URGENT FIELD SAFETY NOTICE

Commercial name of the affected product: *AIRO Mobile CT Scanner (model# MobiCT-32)*
EU FSCA Identifier: 2018-FSCA-001 / US FCA Number: 3010151377-0080118-001C

Type of action: *Advice regarding the use of the AIRO / Device Modification*

- **Date:** August 2, 2018

Figure #1

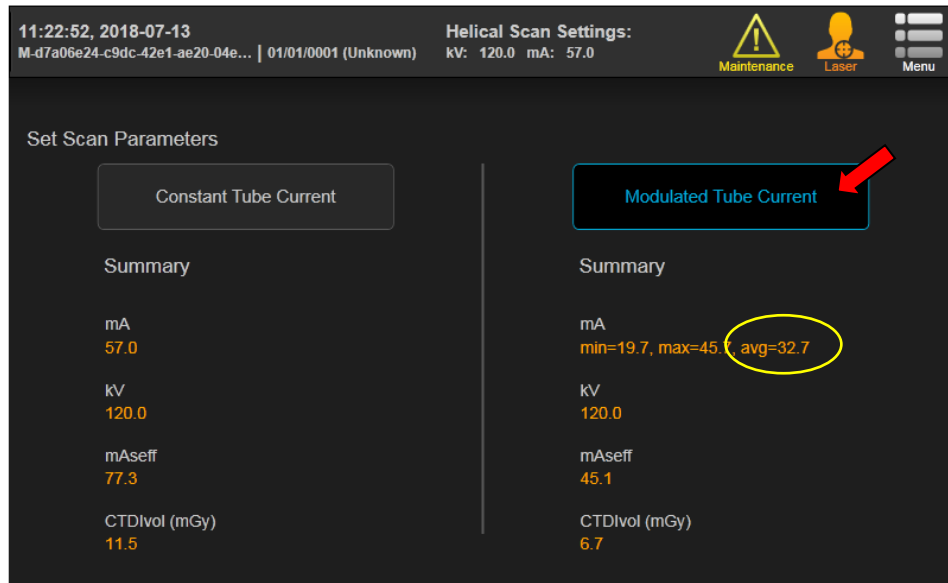
Due to an error in AIRO software version 2.0.0.0, a non-modulated scan may be performed in place of a selected modulated scan because the window of time for an operator to select either non-modulated or modulated scan is less than 1 second before the default selection (non-modulated) is selected by the system.

If the operator selected a modulated scan ("Modulated Tube Current", see figure #1), the system would display the modulated scan parameters and the operator would believe that a modulated scan was being performed (see figure #2) and would only know that a non-modulated scan was actually performed by reviewing the scan slice data after the scan was completed (see figure #3). The amount of dose displayed (in figure #3) and recorded for each slice of the scan correctly reflects the actual delivered dose.

Mobius Imaging is advising all customers using AIRO systems with software version 2.0.0.0 to not select the modulated scan option, since scans will not be performed according to the parameters displayed for this option. Customers shall only select the non-modulated scan option until the software patch has been installed on their system.

Mobius Imaging is currently working on an update to the software (software patch), to correct the issue and ensure that the type of scan selected by the operator will be performed. The software patch is tentatively planned to be available for AIRO systems by the end of August 2018. Brainlab will actively contact affected customers immediately to schedule the installation of the update once it is available.
